LAND AT OAKLEY FARM, BATTLEDOWN, CHELTENHAM

TRANSPORT ASSESSMENT ADDENDUM

ROBERT HITCHINS LIMITED

NOVEMBER 2020

Drawing No. **H628/06** Rev B
Date: February 2020 Scale: As shown @ A0
E-Mail: wniener@pfapl.com

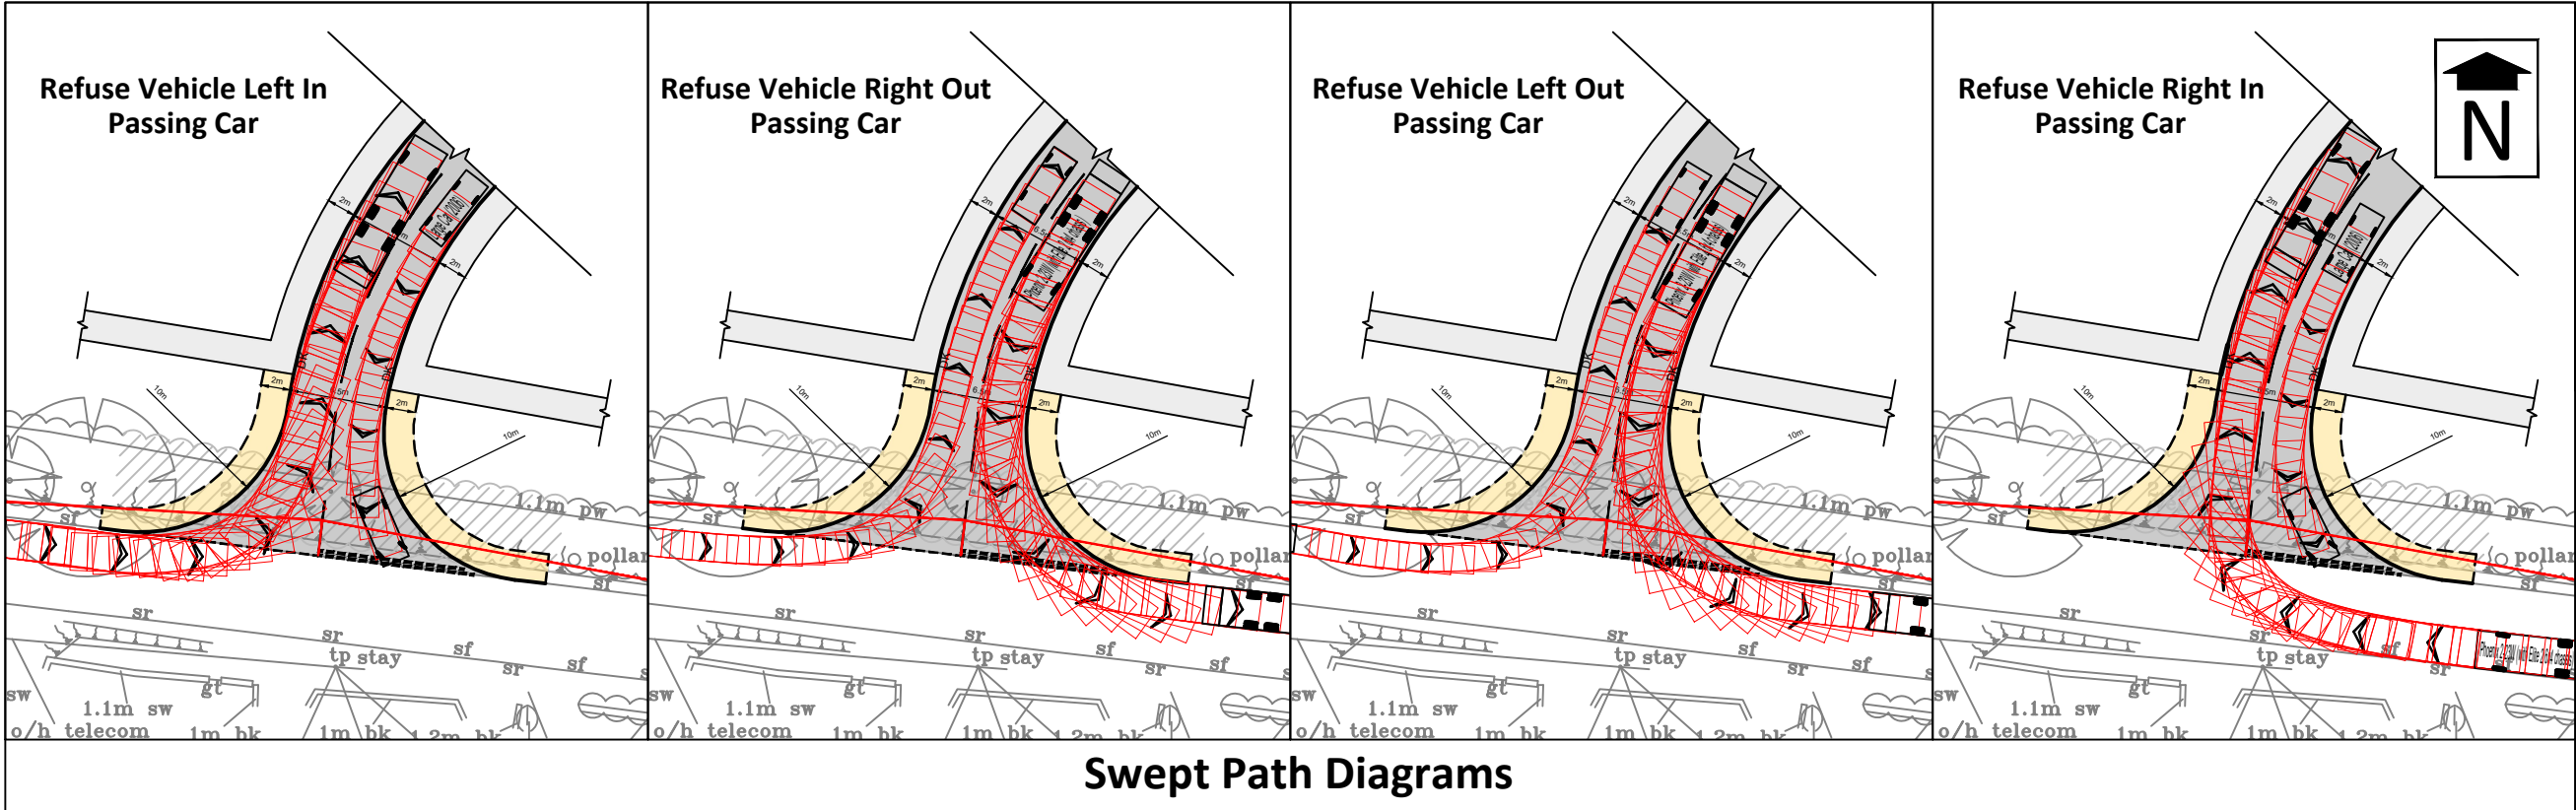
- 2.1. GCC has requested a comprehensive drawing showing the full length and width of the proposed shared footway / cycleway on to Priors Road, including details of the proposed toucan crossing and route to Whaddon Road.

The application proposes a shared use cycleway/footway on to Priors Road. Insufficient detail as been provided on this connection. Drawing H828/06 (in appendix H) show part of this link, but no dimensions are provided, a comprehensive drawing showing the full length and width is required. It also shows a new toucan crossing and cycleway, the applicant should show details of the cycleway width and design standards, and the visibility of the crossing given the adjoining street trees. Additionally, the proposal oversails the existing public footpath, this is important as it is unlawful to cycle on a footpath, therefore the owner of the site would need to convey a higher access right to allow cycling to occur. Without higher rights existing the site would rely on Harp Hill for cycle access only which is not considered to be suitable due to the gradient.

- 2.3. A preliminary design of the proposed shared footway / cycleway along its entire length is shown in PFA drawing H628/06 Rev B reproduced at a reduced scale at **Appendix C**. The design has considered the recent Department for Transport (DfT) guidance contained in Local Transport Note 1/20 - Cycle Infrastructure Design and the Traffic Signs Manual Chapter 6 with respect to the proposed toucan crossing.

Drawing No. **H628/02** Rev D

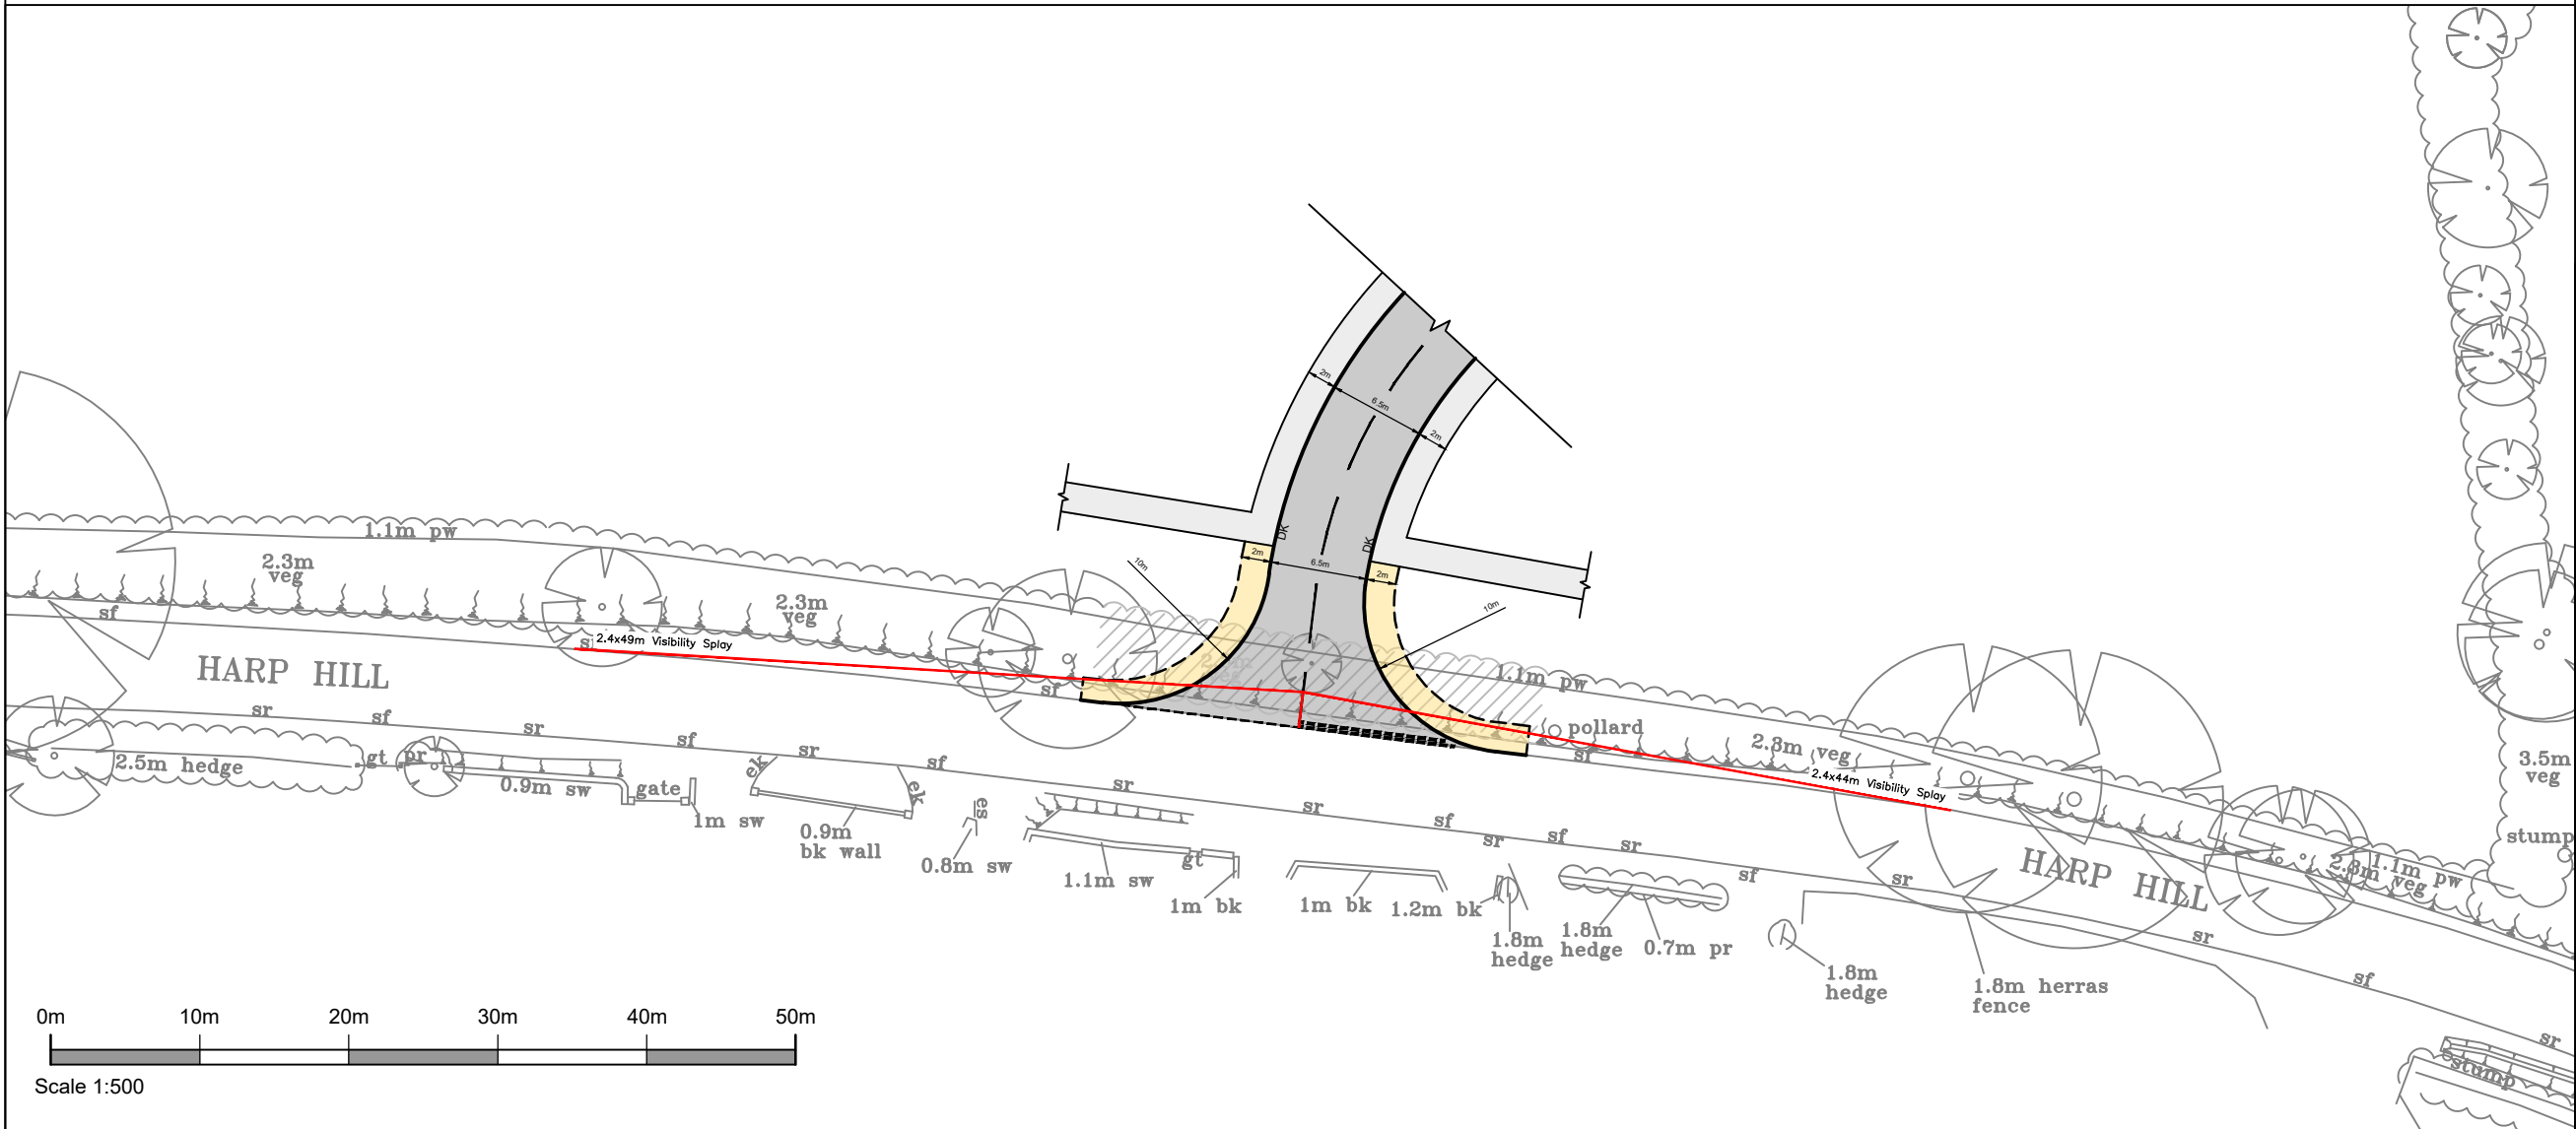
- 3.1. GCC requested that the preliminary design of the proposed site access junction on Harp Hill provide details of the dimensions of the access and also vehicle tracking. The preliminary design of the site access has therefore been updated to include dimensions and vehicle tracking as shown in PFA drawing H628/02 Rev D at **Appendix D**.

The proposal provides a new bellmouth onto Harps Hill, this is supported with visibility splays using the 85th percentile approach speeds. The proposal however fails to provide any details of the dimension of the access or any tracking details and as such this access cannot be agreed. The access also needs to account for the entry into the site, observation indicates that there is a considerable gradient from the access into the site. The applicant has provided an indicative long section this shows a 1 in 20 gradient onto Harp Hill, however to access the majority of the development 160m of 1 in 12.5 is shown, this is unacceptable and no greater lengths than 30m are permitted at that gradient, additionally 1 in 20 should be maintained at the junction. The information submitted is lacking in terms of detail of the access and the indicative sections shows significant challenges which even with considerable earth works would be unacceptable.

Rev	Date	Description	Drawn	Check
D	21/11/20	Access widened to 6.5m	TLH	JA
C	04/11/20	Junction dimensions and vehicle tracking added	TLH	JA
B	26/02/20	Illustrative Masterplan Base Updated and Project Title Changed.	RH	ECS
#	18/10/19	First Issue.	THP	ECS
